SUBJECT: COMANCHE PEAK STEAM ELECTRIC STATION, UNITS 1 AND 2 - AMENDMENT  
NOS. 46 AND 32 TO FACILITY OPERATING LICENSE NOS. NPF-87 AND NPF-89  
(TAC NOS. M91244 AND M91245)

These amendments change TS 5.6, "Fuel Storage" to authorize usage of the high density fuel storage racks, to increase the spent fuel storage capacity, and to adopt the wording, content, and format of the Improved Standard Technical Specifications.

ATTACHMENT TO LICENSE AMENDMENT NOS. 46 AND 32

SAFETY EVALUATION BY THE OFFICE OF NUCLEAR REACTOR REGULATION

FIGURE 5.6-1

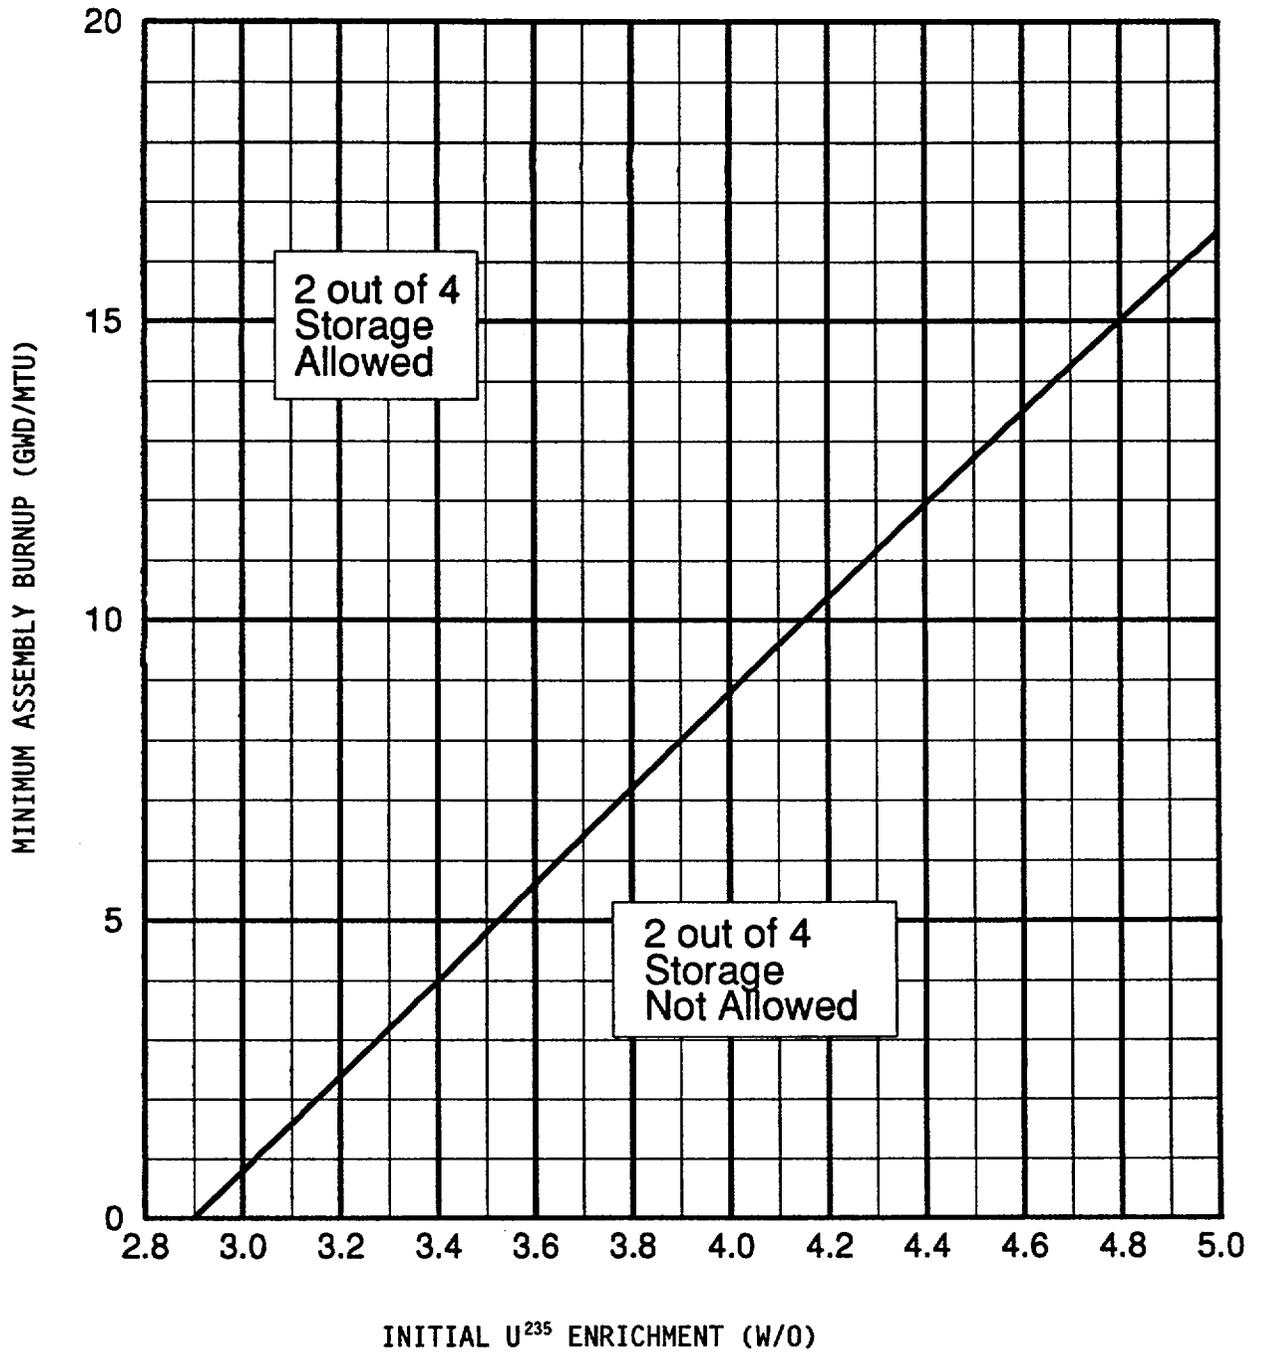
- f. New or partially spent fuel assemblies which meet the minimum burnup-initial enrichment requirements of Figure 5.6-1 are allowed restricted storage in a checkerboard (2 out of 4) pattern in the high density fuel storage racks.

In order to store fuel with nominal enrichment greater than 2.9 w/o U-235, but no greater than 5.0 w/o U-235, in a 2/4 checkerboard pattern, the concept of burnup reactivity equivalencing was used. This concept is based on the reactivity decrease associated with fuel depletion and has been previously found acceptable by the NRC for use in pressurized water reactor (PWR) fuel storage analysis. A series of reactivity calculations is performed to generate a set of enrichment versus burnup ordered pairs which yield an equivalent  $k_{eff}$  for fuel stored in the CPSES high density SFP2 racks. The results of these calculations indicate that a fresh 2.9 w/o fuel assembly yields the same rack reactivity as a nominally enriched 5.0 w/o assembly
